Standard Development Application

Location Address: 4600-4607 S.W. 44th Avenue

Revised December 29, 2015 (DRC1)

RE: **GRIFFIN COMMERCIAL CENTER
DRC COMMENT RESPONSE LETTER
CITY OF DANIA BEACH PROJECT NOS. SP-125-15 & VA-126-15
CTA PROJECT NO. 15-0055**

HYDRANT # 2	DATE	TIME	
FLOW	1/6/16	9:10:15 AM	975.8 GPM
PRESSURE	1/6/16	9:10:15 AM	49.085 PSI

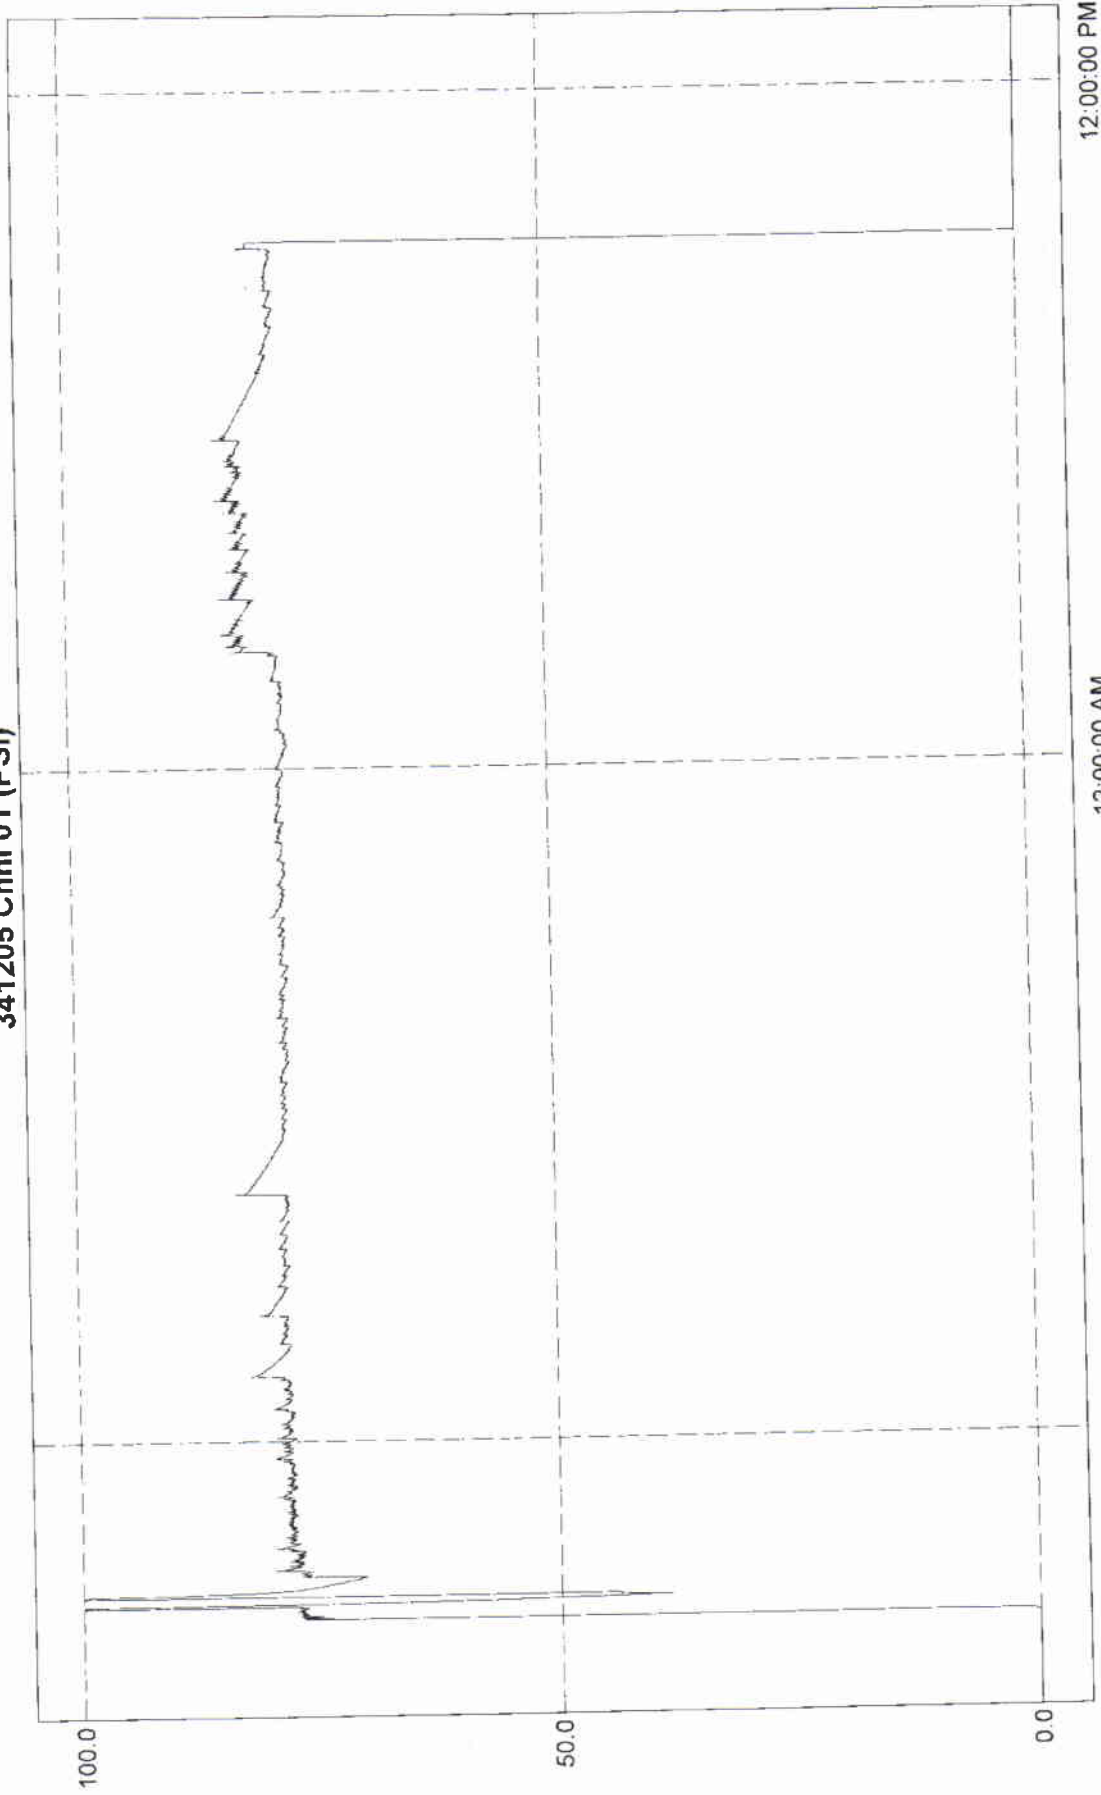
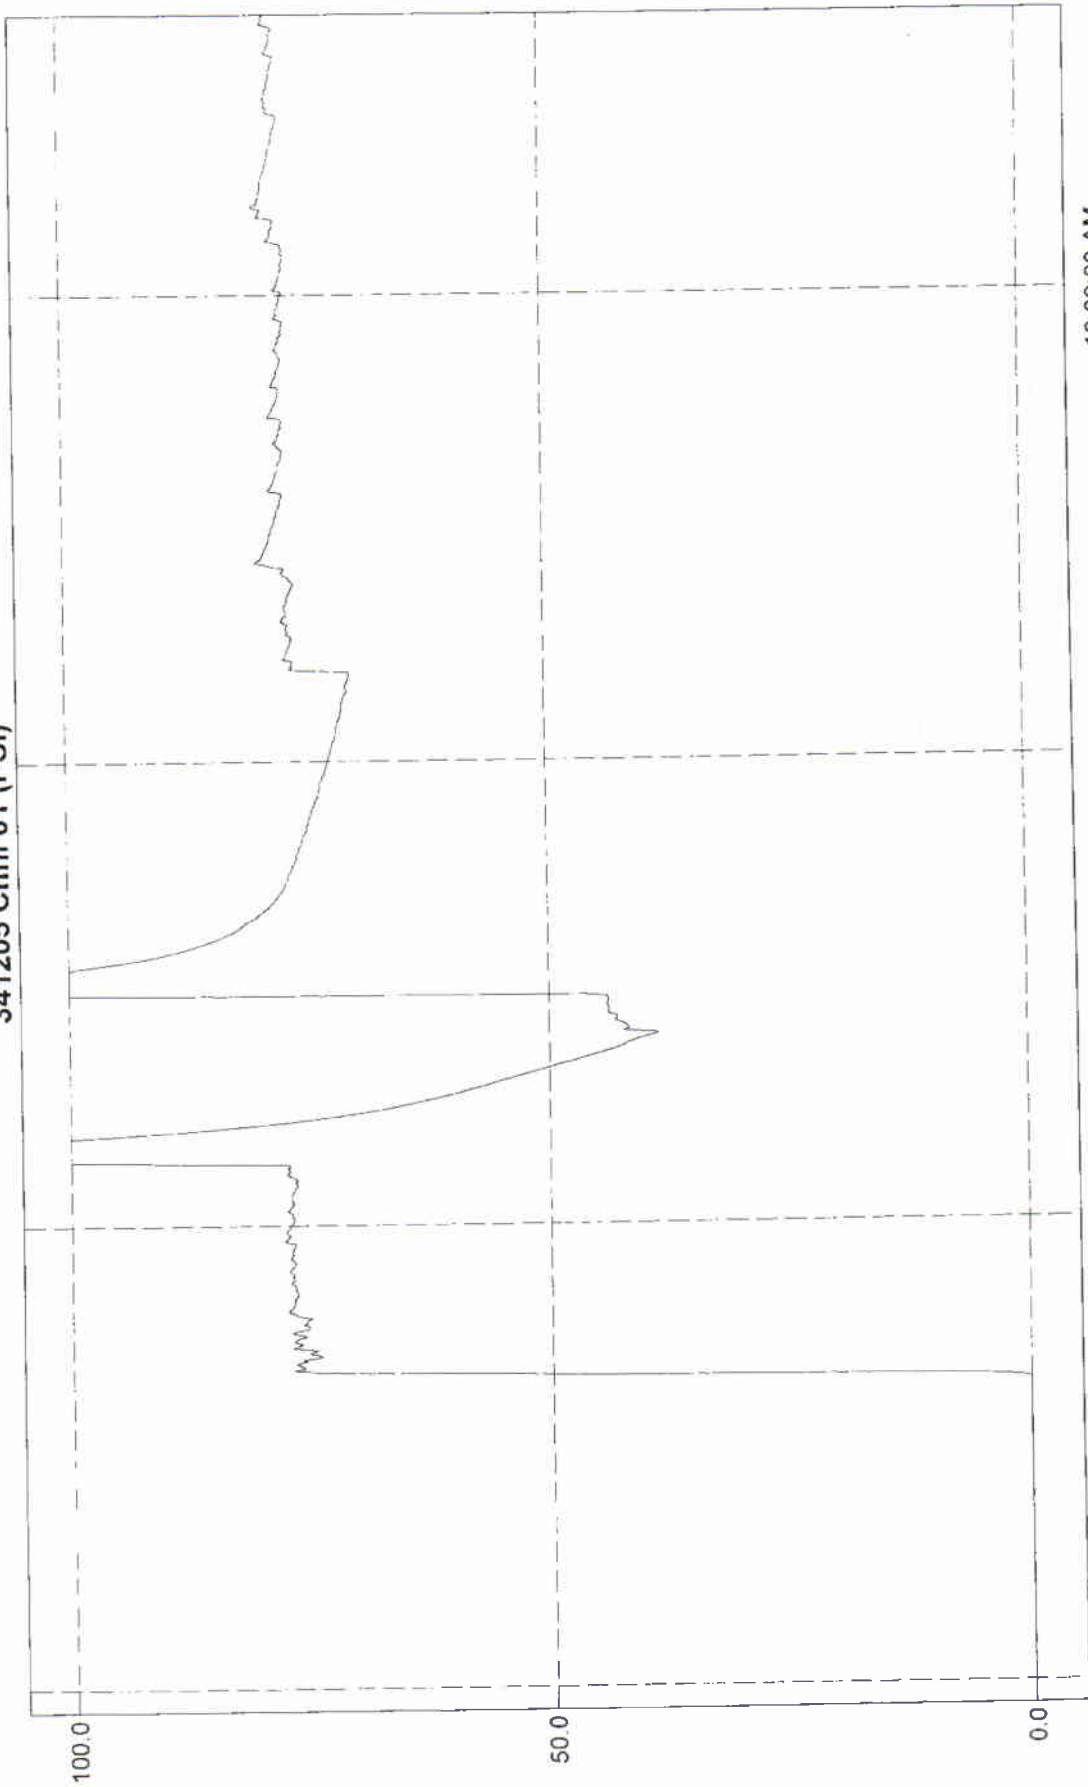
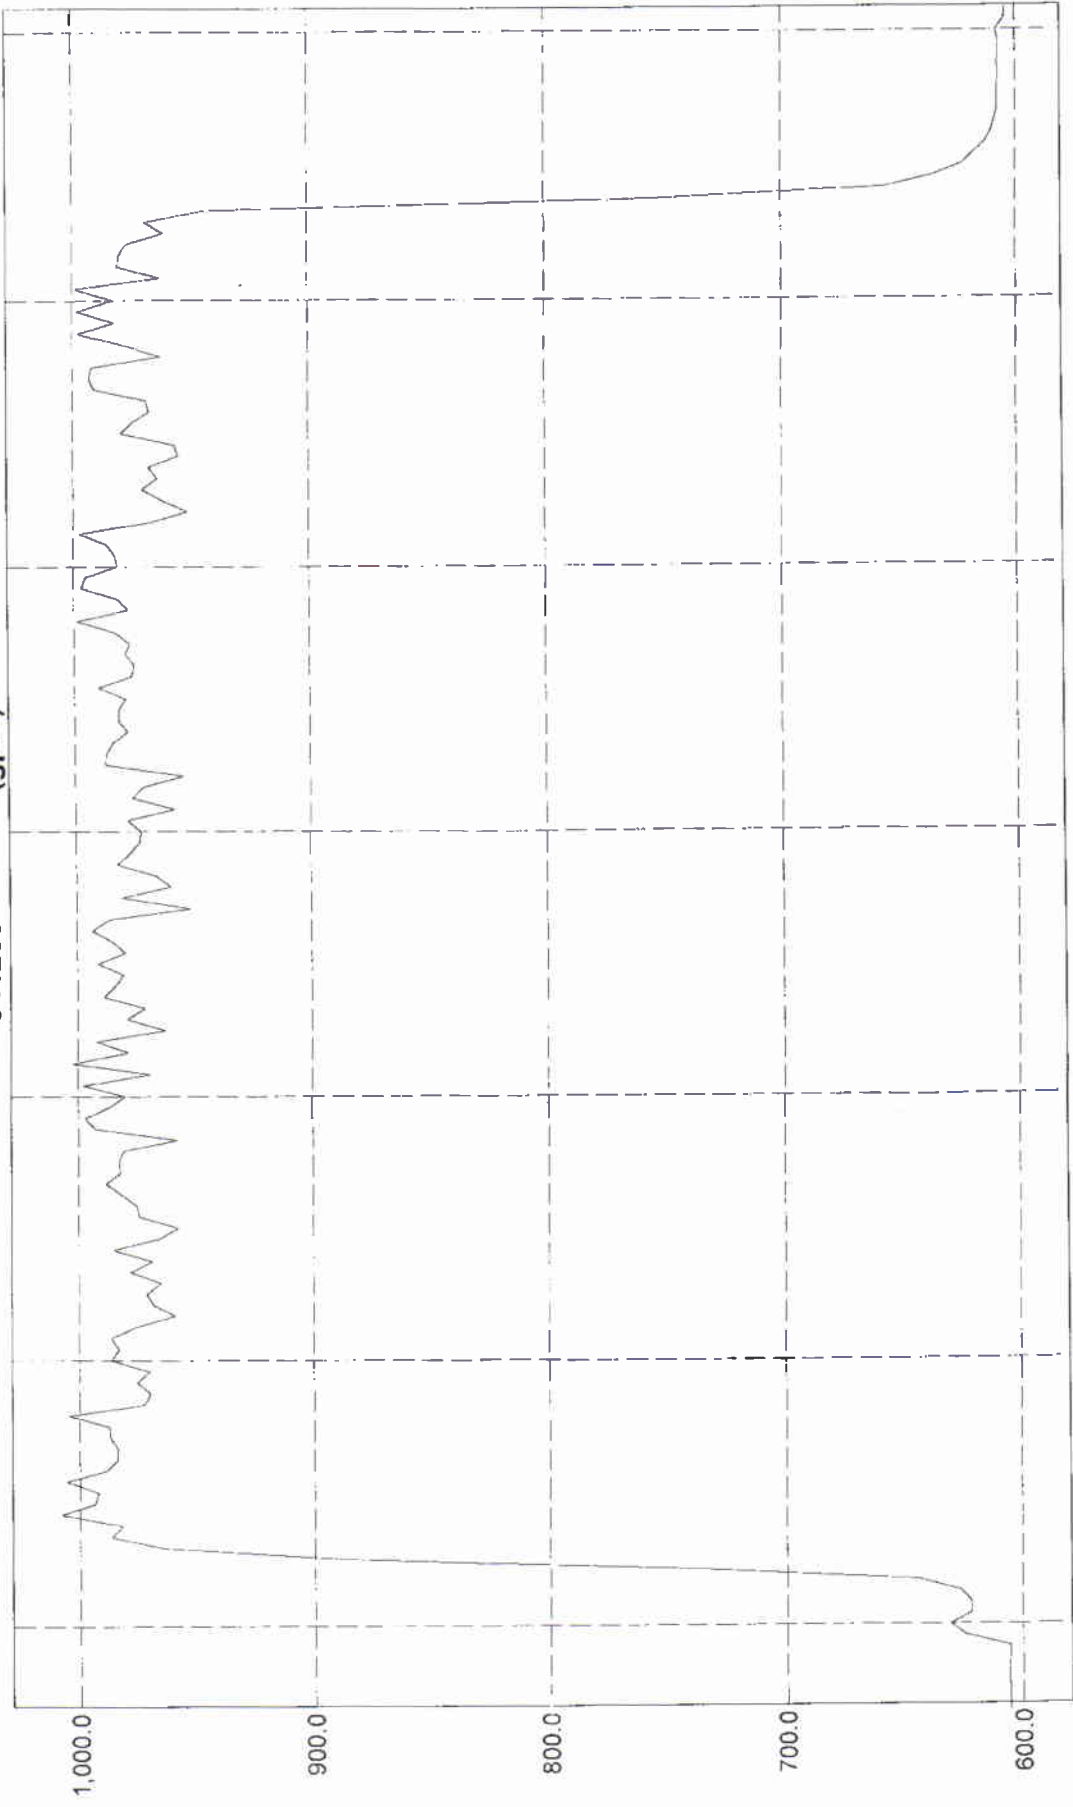
11. Fire Hydrant Flow Test – Still needed.
Response: A Fire Hydrant Flow Test has been completed and is attached.

PROJECT NO. 15-0055-002-01
 SHEET C-1 OF C-1

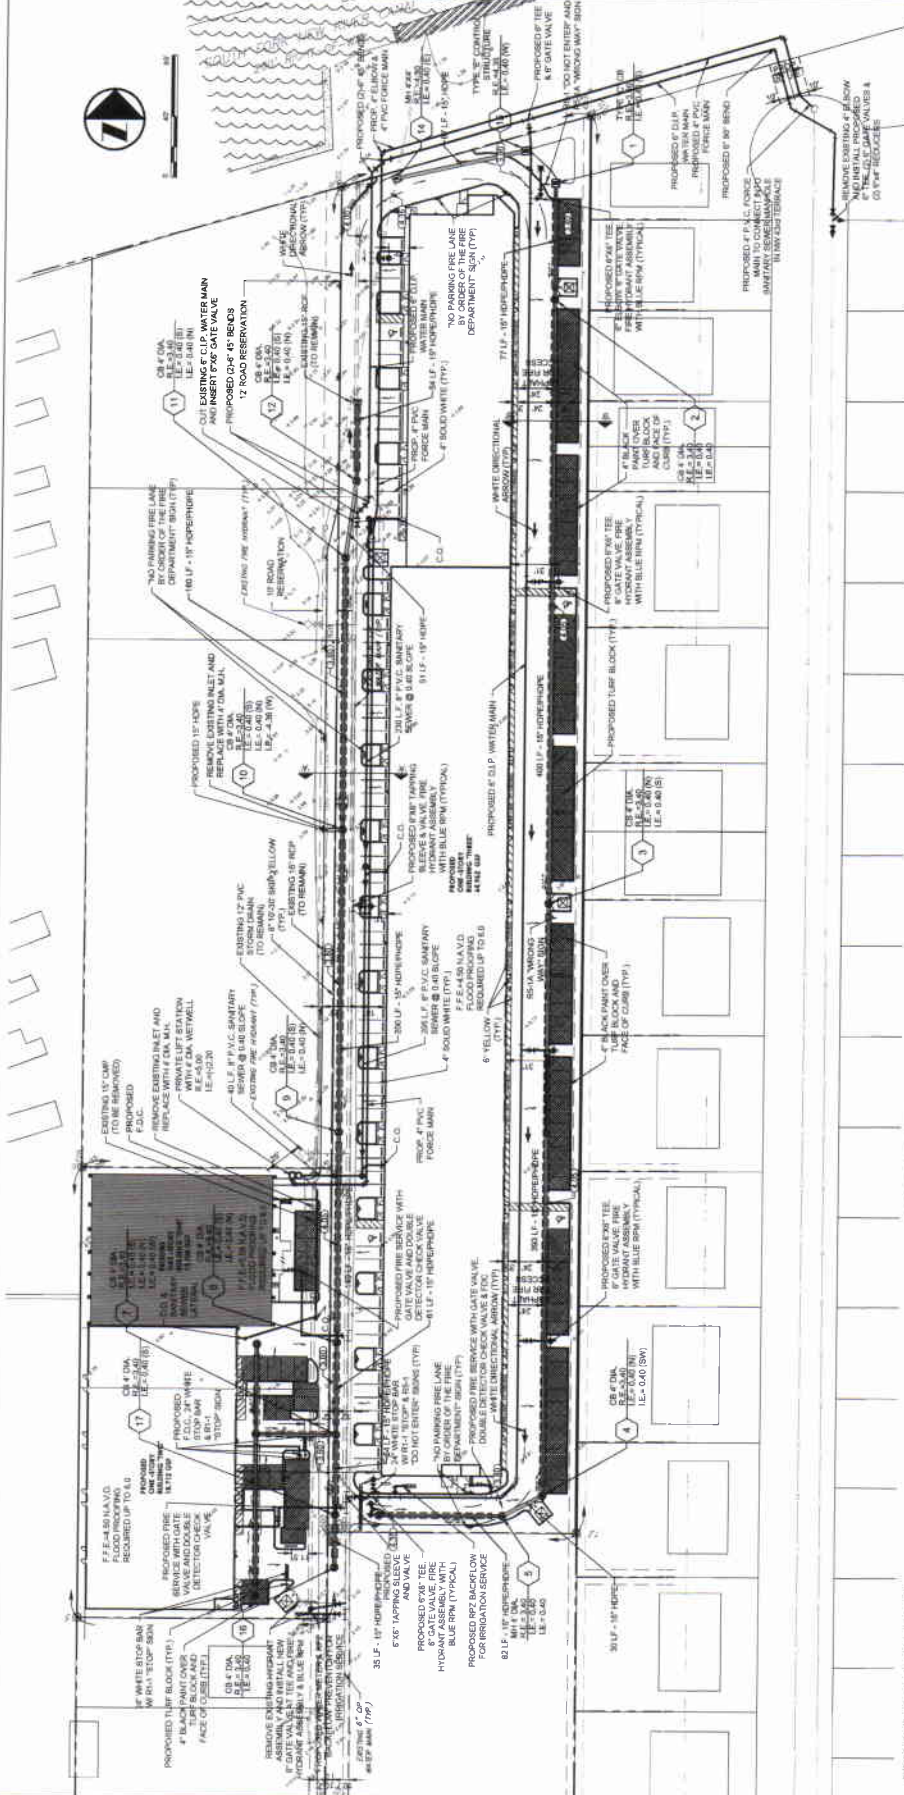
A copy of the updated Traffic Report is attached as a pdf file as well as a copy of the Preliminary Engineering Plans. I need to provide confirmation to Corinne Lajoie that your comments have been addressed. Will you please review the response to comments below, along with the attachments and confirm your comments have been addressed.

PROJECT NO.: 15-0055-002-01
 SHEET NO.: C-1 OF C-1

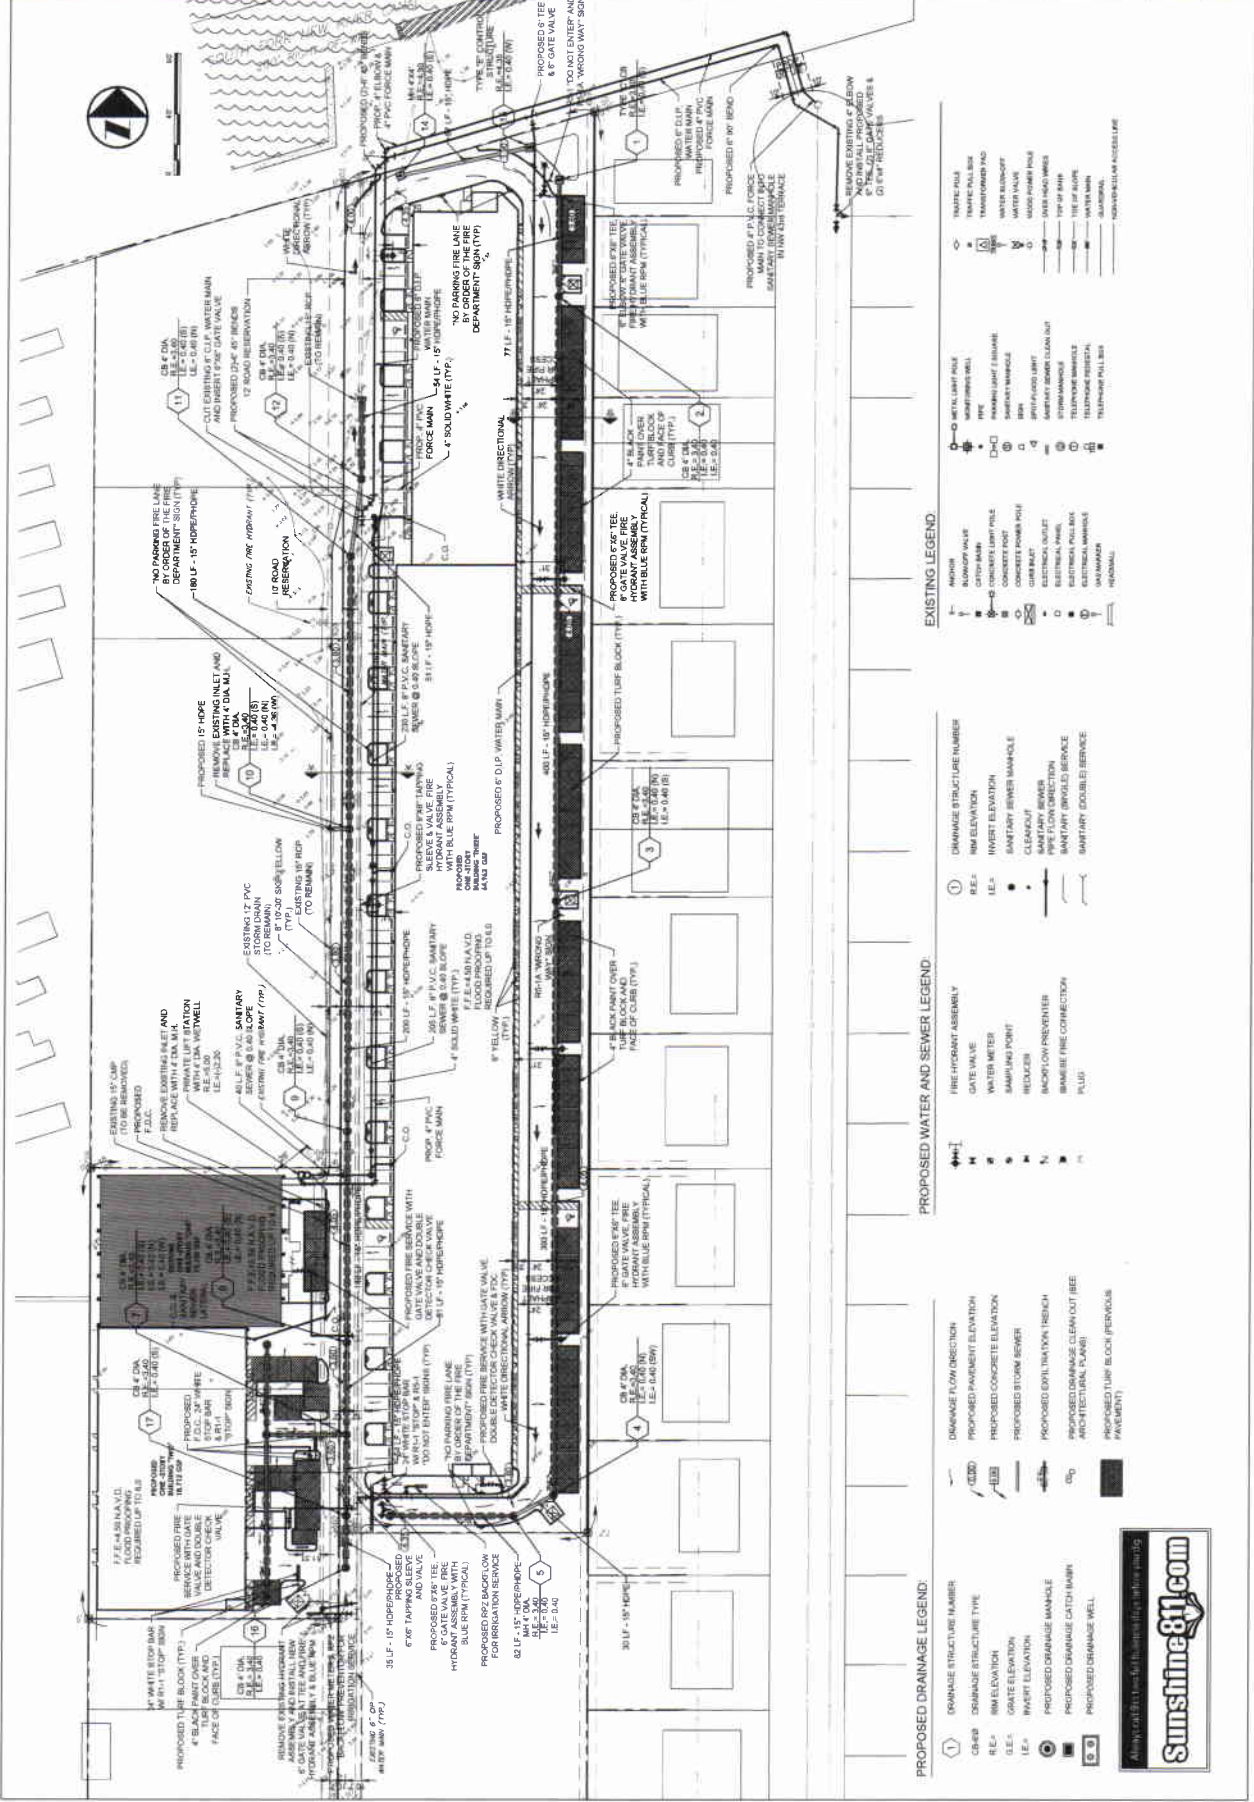
I found a couple minor changes that need to be made. Please see attached review and revise sheet C-1 to reflect the changes. Once those changes are made, send me back the revised sheet C-1 and I can give the approval to Corinne. All other comments have been addressed and comply with code.
